Quick investigation of BA15 cap-holder systems

Evaluation proposal Valeo (reference TF SR-01-10)

Examination Valeo Proposal:

Check: BAZ15-LED Holder-^{v/s} non-LED caps Ref pin in new slot

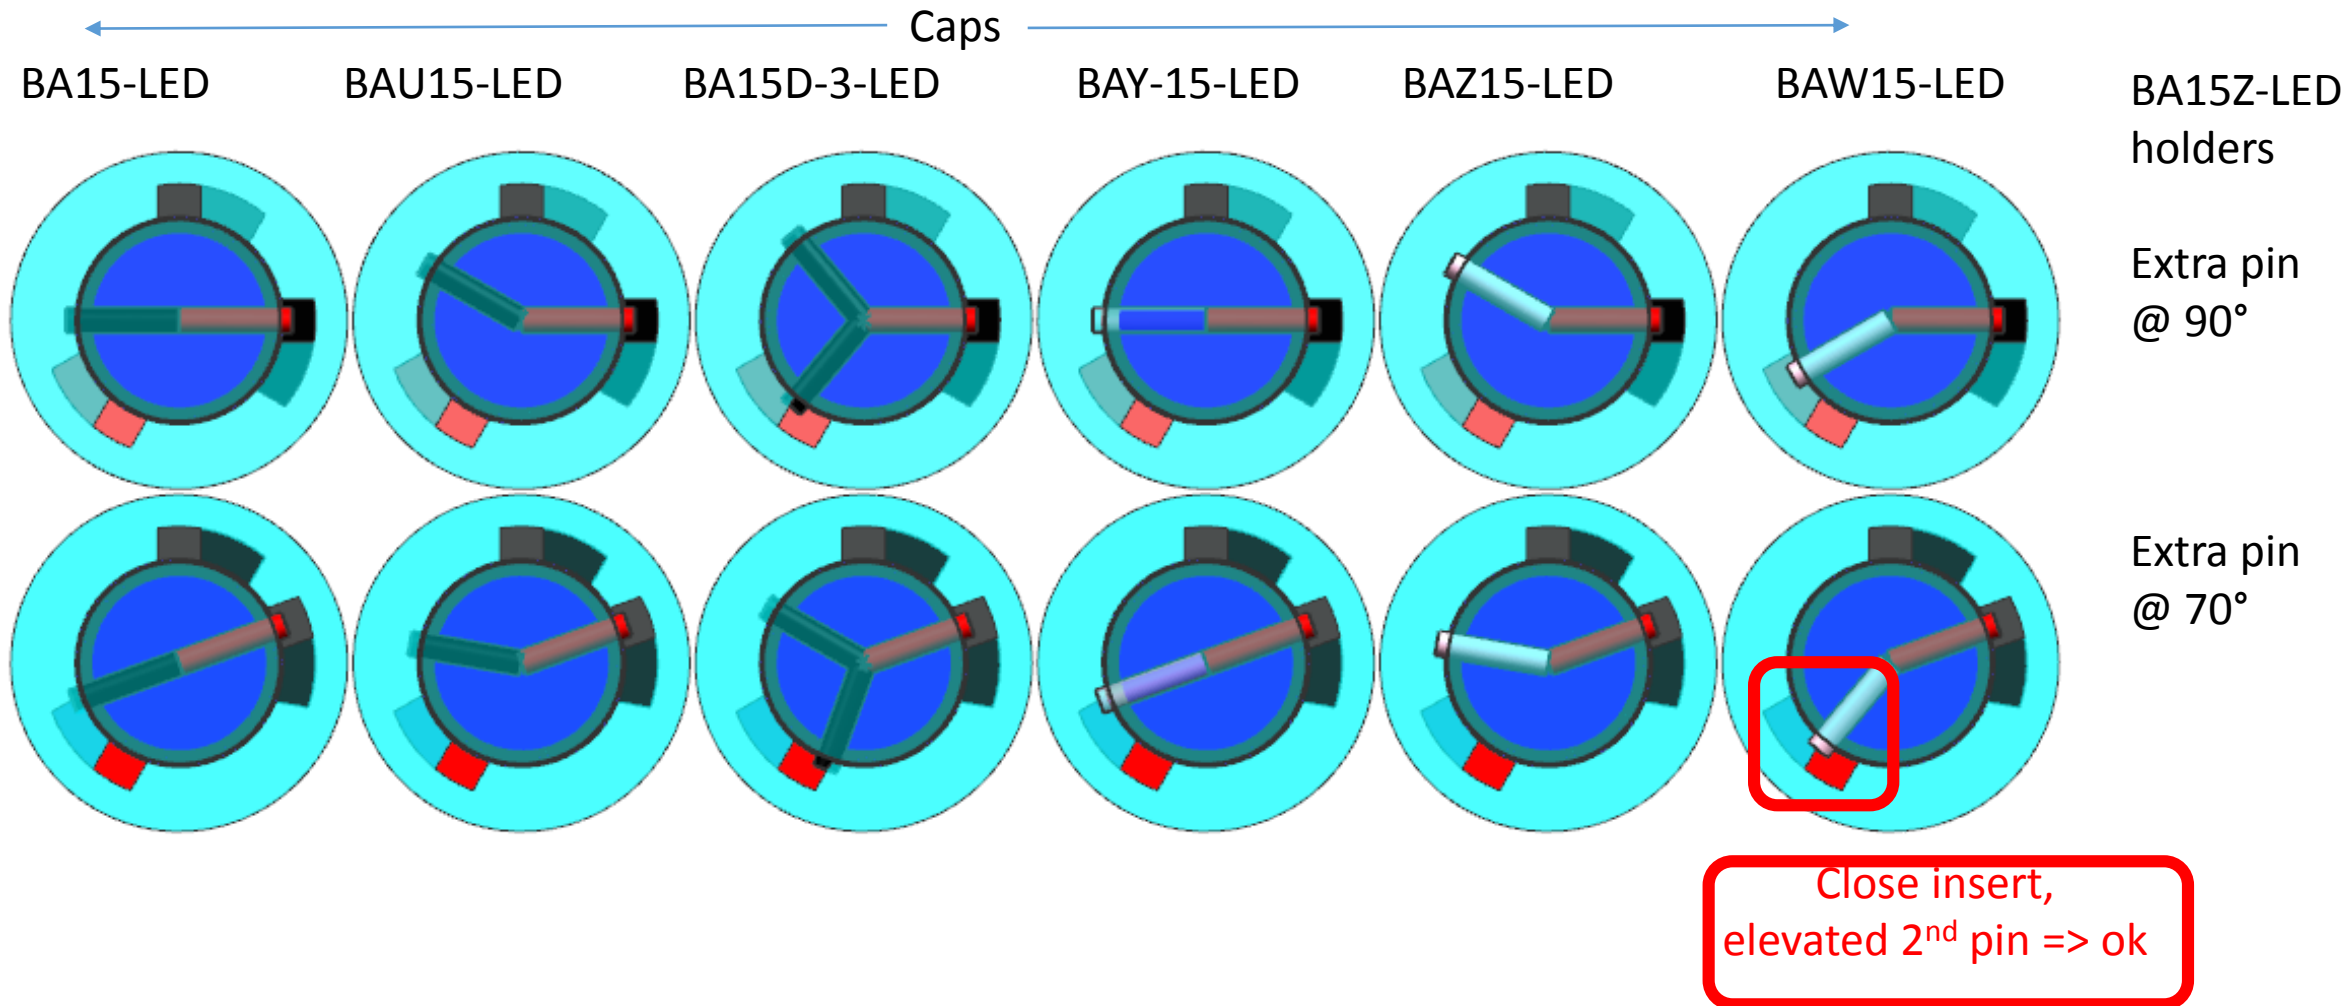
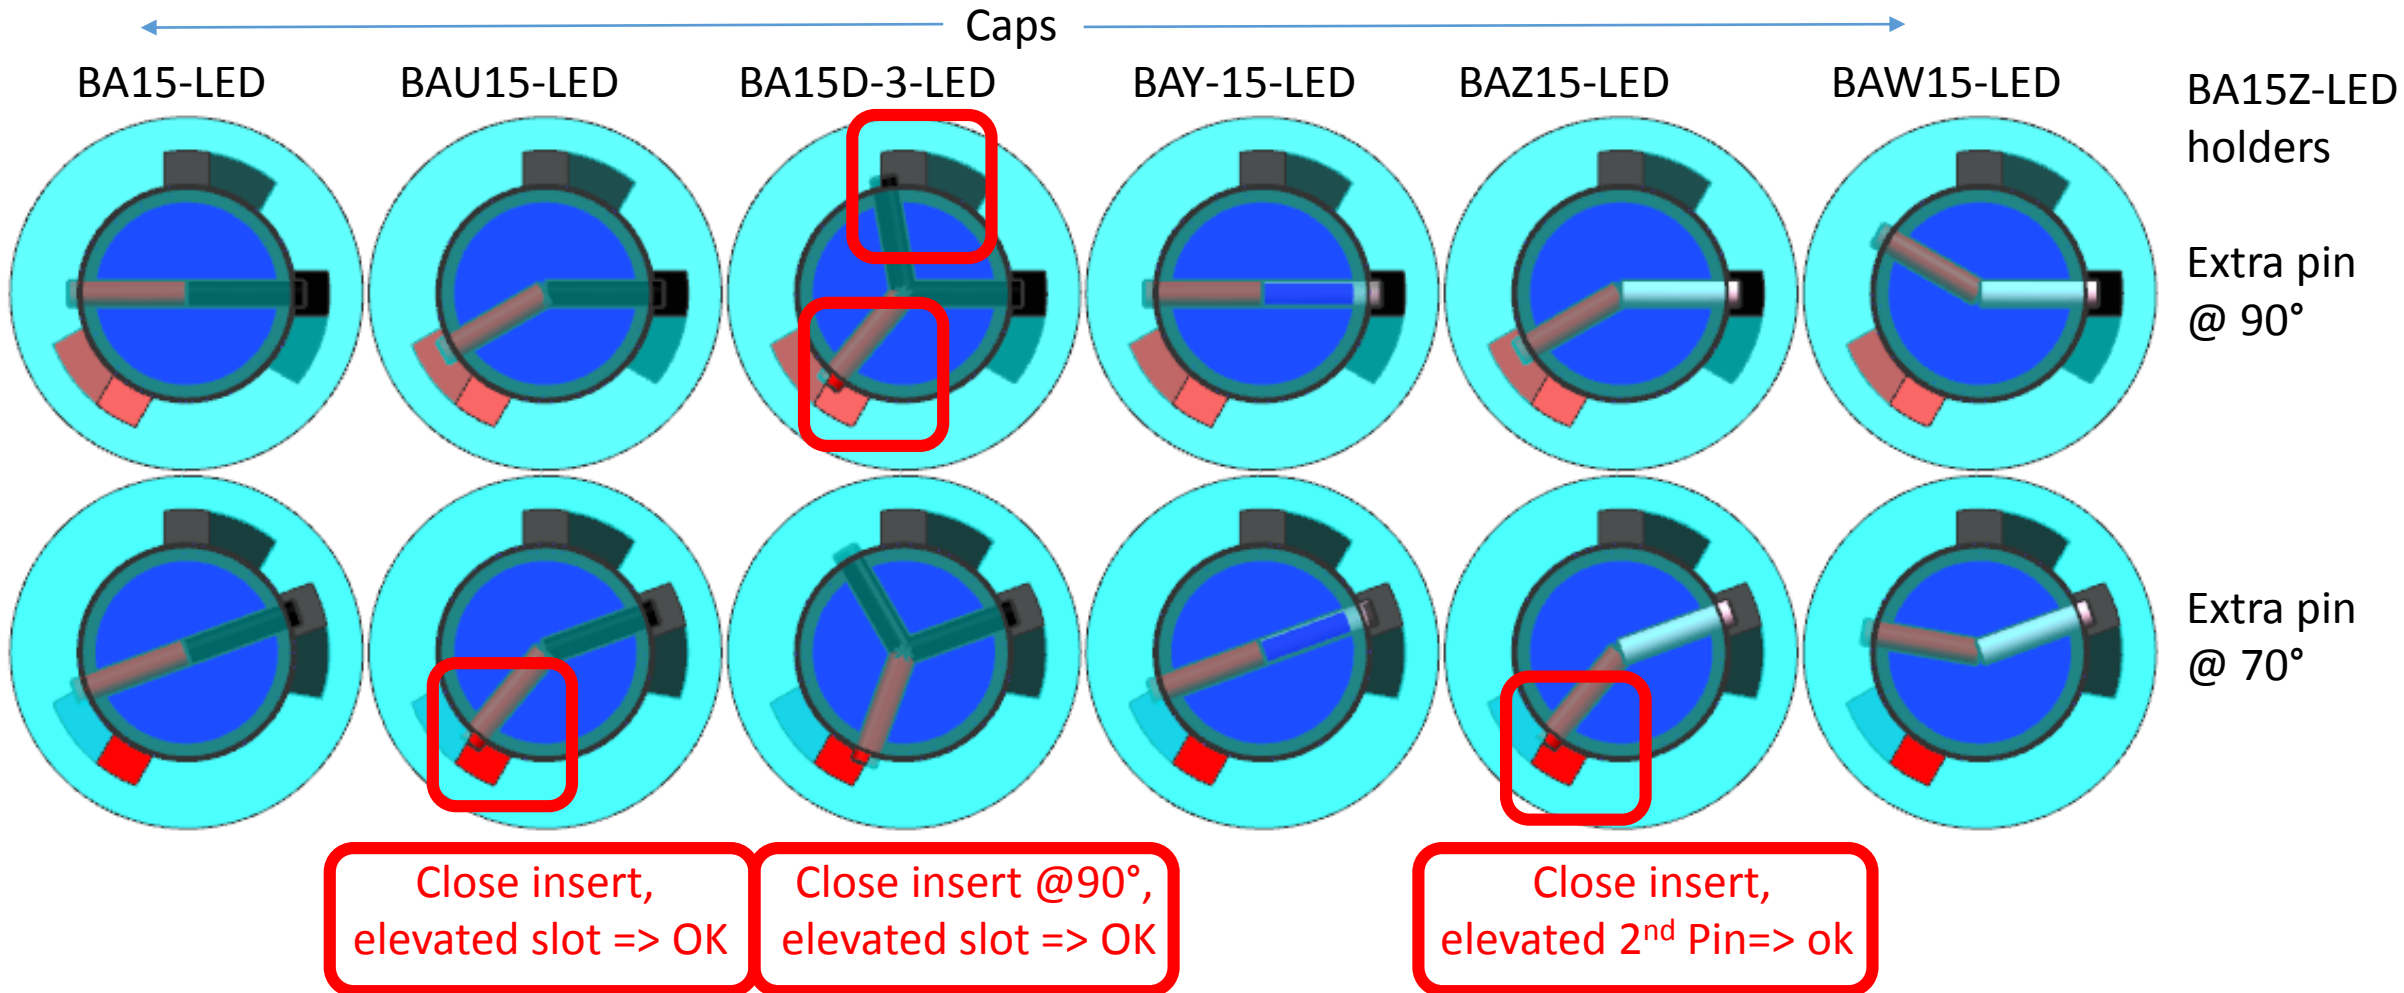
Check: BAZ15-LED Holder-^{v/s} non-LED caps Non-Ref pin in new slot

Check: BAW15-LED Holder- \forall_s non-LED caps Ref pin in new slot

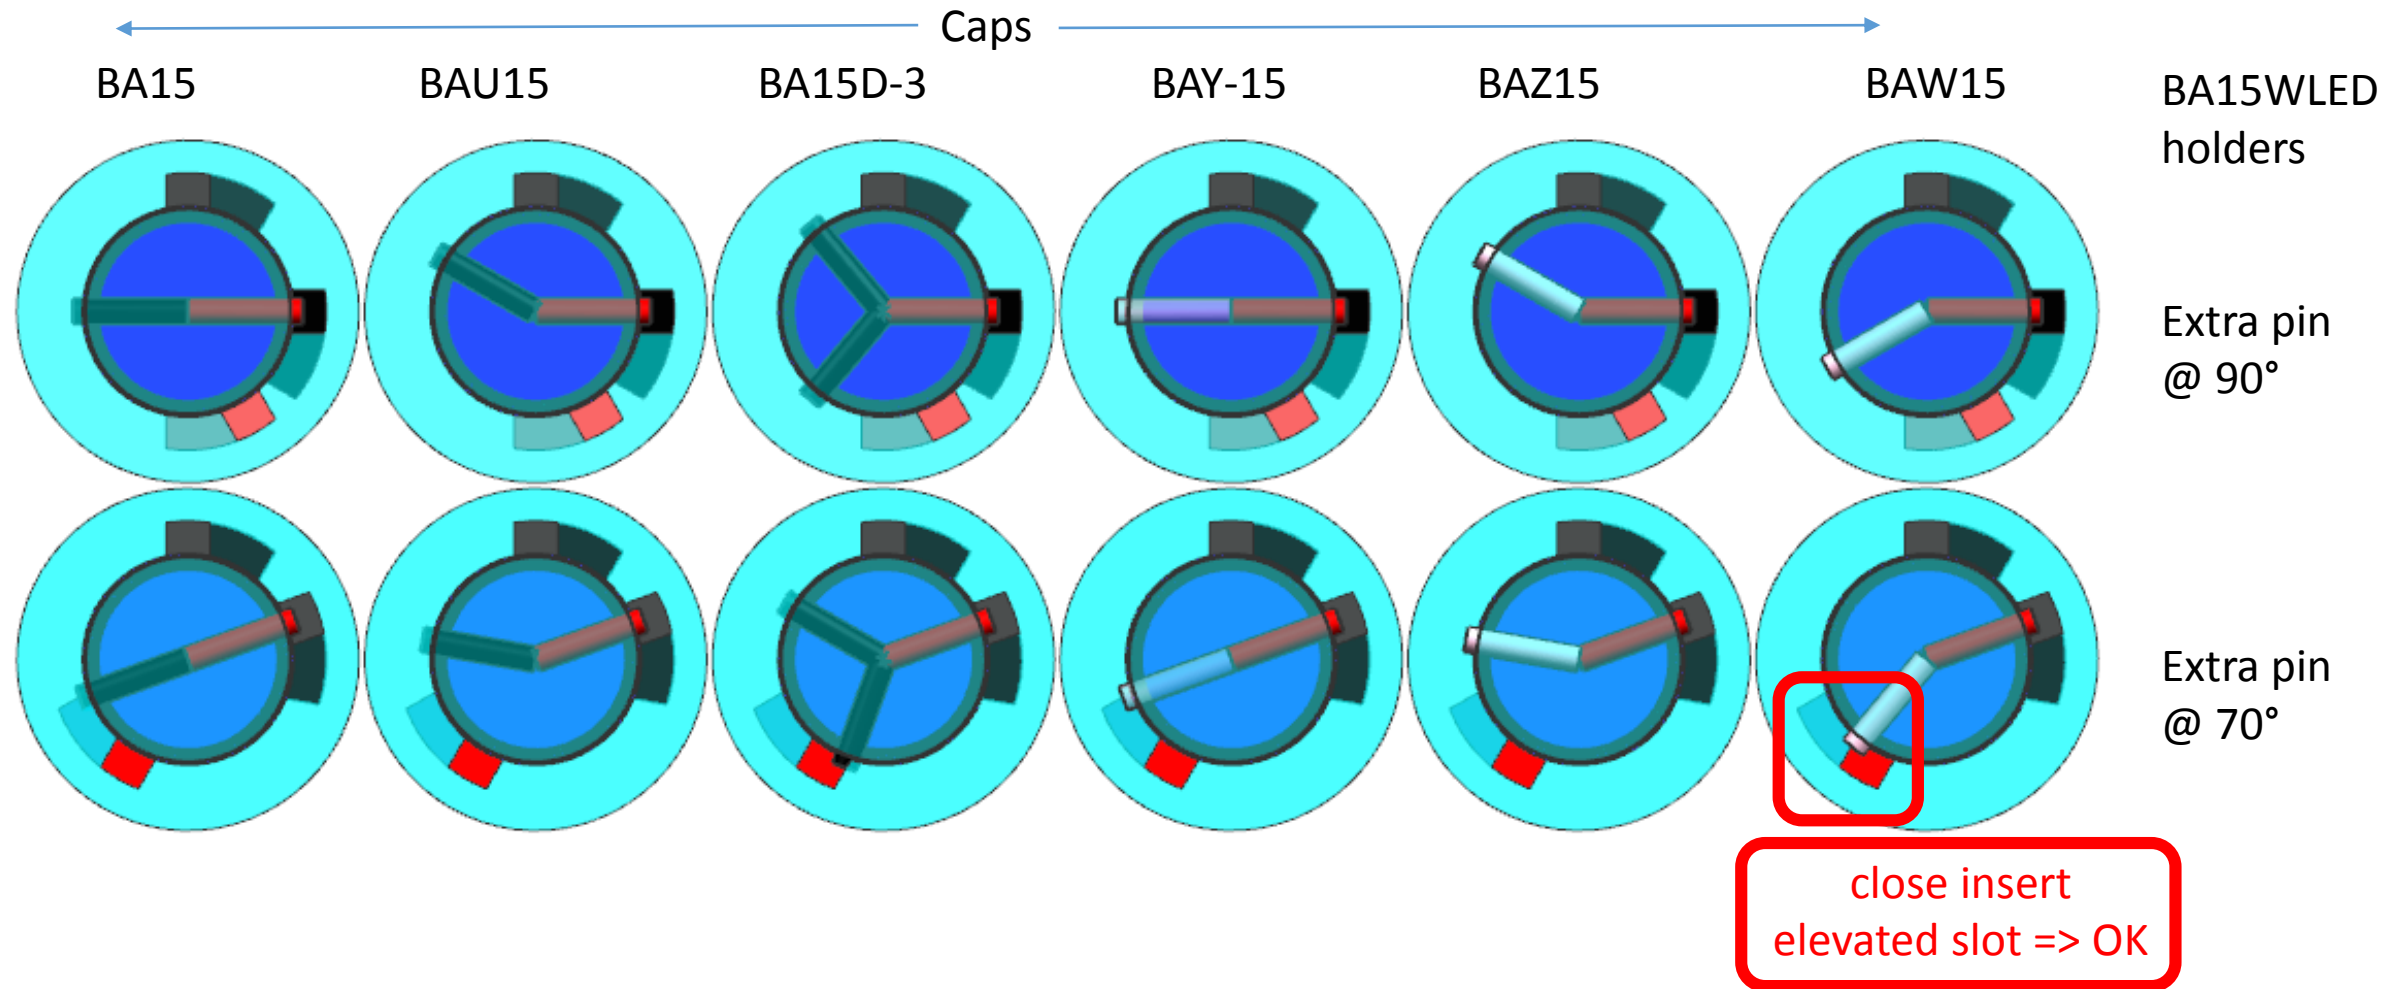
Check: BAW15-LED Holder- \forall_s non-LED caps Non-Ref pin in new slot
